# UNITED STATES PATENT AND TRADEMARK OFFICE

APPLICATION NO.	FILING DATE	FIRST NAMED INVENTOR	ATTORNEY DOCKET NO.	CONFIRMATION NO.
09/822,045	03/30/2001	John Gary Sousa	PTK-194	8435
21323	7590	11/21/2003	EXAMINER	
TESTA, HURWITZ & THIBEAULT, LLP HIGH STREET TOWER 125 HIGH STREET BOSTON, MA 02110			JACKSON, CORNELIUS H	
			ART UNIT	PAPER NUMBER
			2828

<b>Office Action Summary</b>	Application No.	Applicant(s)	
	09/822,045	SOUSA ET AL.	
	Examiner	Art Unit	
	Cornelius H. Jackson	2828	<i>AW</i>

## **DETAILED ACTION**

**FIG. 6**

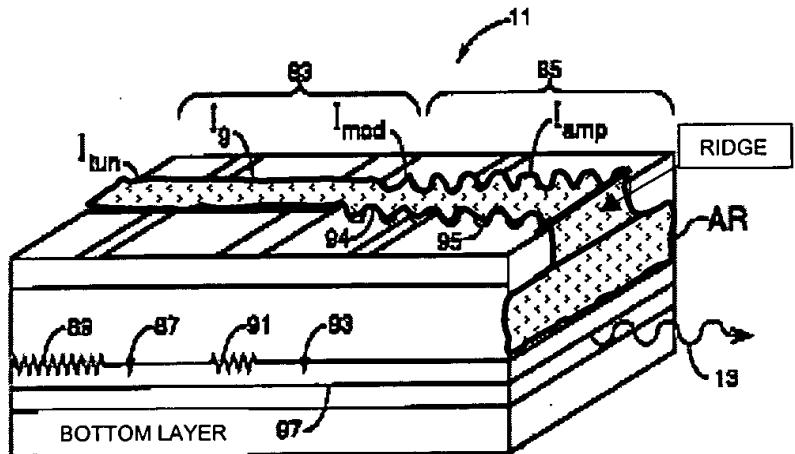
anticipated by Lang et al. (5936991).

Lang et al. disclose a diode laser Fig. 6 comprising a plurality of semiconductor layers including a top layer with a ridge, a bottom layer, and an intermediate emission layer 97,

the layers each having a refractive index associated therewith, the refractive index of the emission layer differing from the refractive indices of the top and bottom layers; a dopant region contained by the ridge; means for facilitating application of an electric field through the layers, wherein the ridge comprises an elongated segment 83 and a flared segment 85 extending to the first edge AR and all the other stated limitations, **see Figs. 4 and 6, col. 2, lines 15-col. 4, line 43, especially, col. 4, lines 6-43.**
